PERMIT*

**NEW JERSEY DEPARTMENT OF ENVIRONMENTAL PROTECTION
BUREAU OF WATER SYSTEM ENGINEERING
TECHNICAL REVIEWER'S REPORT**

PROJECT NO.: WCP160001

SUBJECT: Replacement of the existing Levine uncovered finished water reservoir by two 2.5 million gallon covered pre-stressed concrete finished water storage tanks with associated water mains and a new utility building for a re-chlorination system and water quality monitoring equipment through SCADA system to achieve compliance with N.J.A.C. 7:10-5.1 and 40 CFR 141.714.

Levine Reservoir Piping Schematic

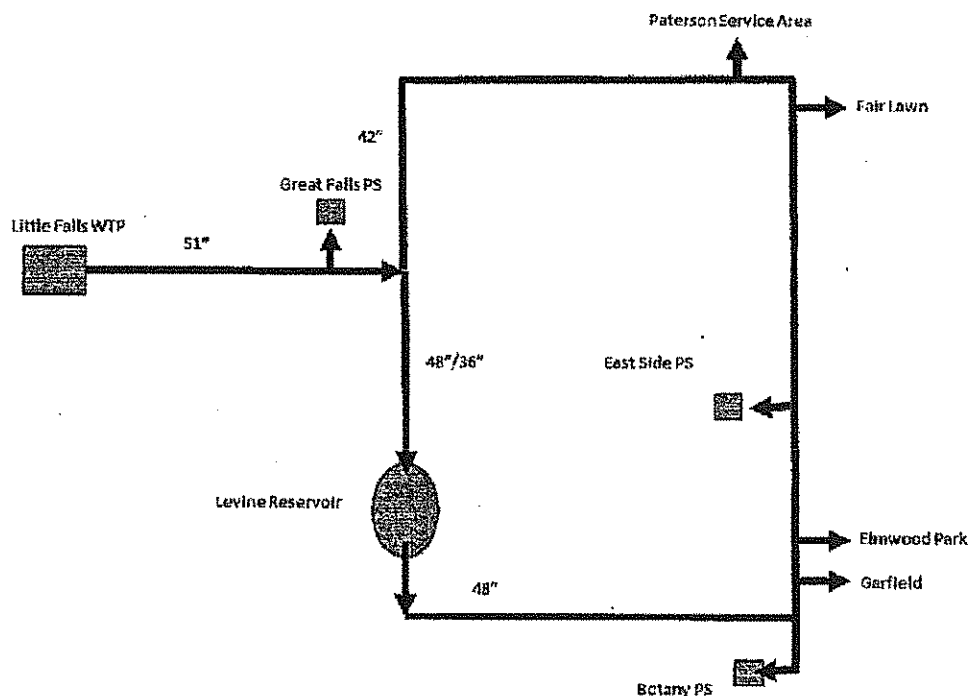
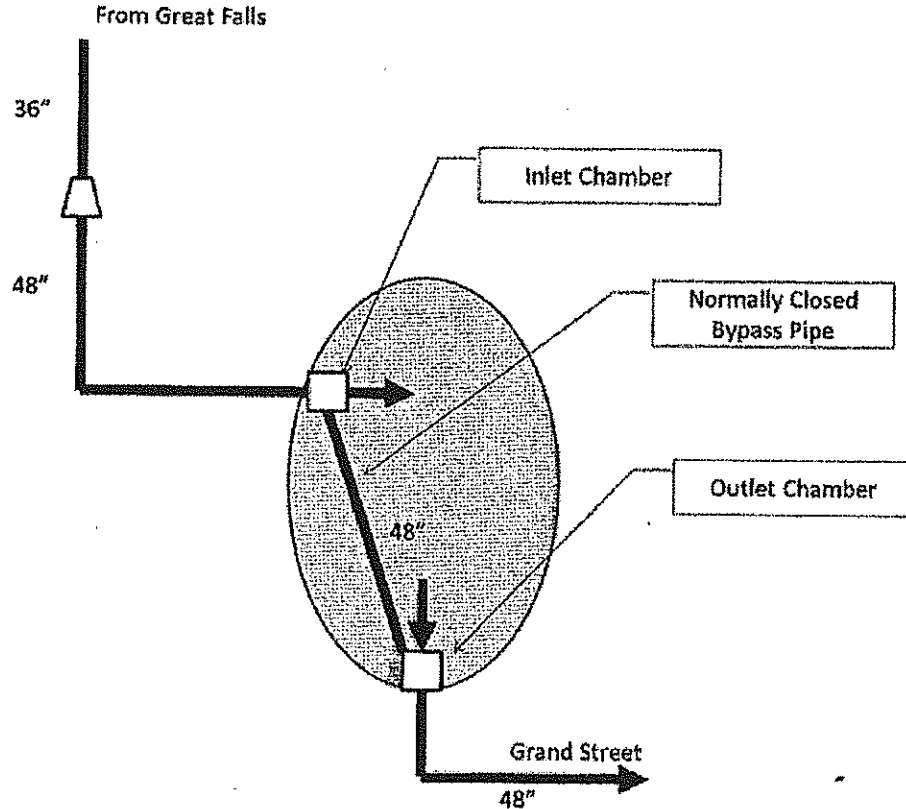
There is an inlet chamber on the west side of the reservoir and an outlet chamber on the south side of the reservoir. Under normal conditions, water enters the reservoir from a 48 inch pipeline at the inlet chamber, and exits the reservoir into a 48 inch pipeline at the outlet chamber. The reservoir can be isolated from the transmission system and flow can be diverted through a 48 inch bypass pipeline laid on the bed of the reservoir, running between the inlet and the outlet chambers.

Figure below illustrates the reservoir inlet, outlet, and bypass piping and structures. There is also a connection from the HG 300 gradient (not shown in the figure) to the reservoir which can be used additional flow through the reservoir to the HGL 180 gradient if needed.

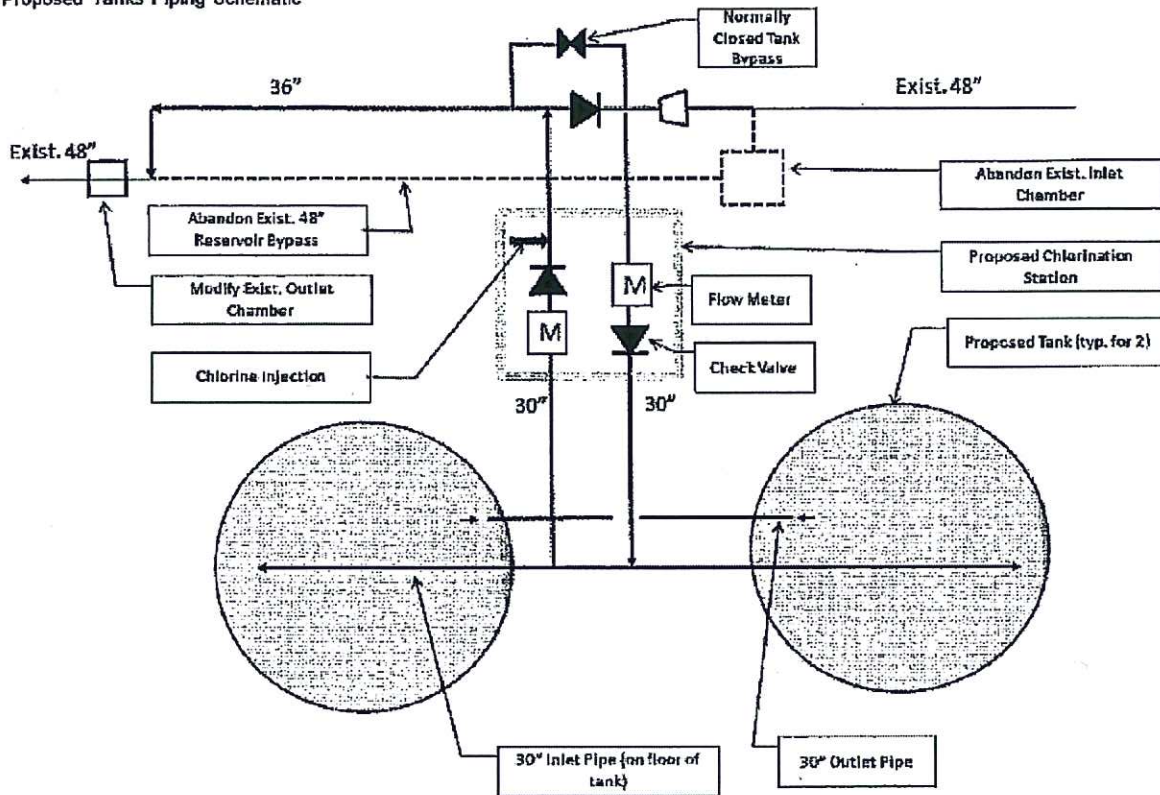
The tanks will also be equipped with low level alarm system. The SCADA system will generate high and low level alarms based on the measured tank levels from the transmitters. The study report shows that a minimum water level would be required to maintain in the tanks at all times to avoid any uplifting slab of the tanks due to high water table in the surroundings. The top of the reservoir base slab is at elevation 175'. Based on 100 year and 500 year storm events, the maximum water surface elevation in the detention ponds will be at 175.2 feet. As a conservative approach, in the event that the outlets from the detention ponds were plugged, the maximum water surface elevation in the detention ponds for 100 year and 500 year storm events is at 176 feet. PVWC has directed CH2M to design the reservoir to resist buoyant uplift for the following conditions:

Groundwater Elevation = 179.0' with Factor of Safety = 1.1

Groundwater Elevation = 180.0' with Factor of Safety = 1.0
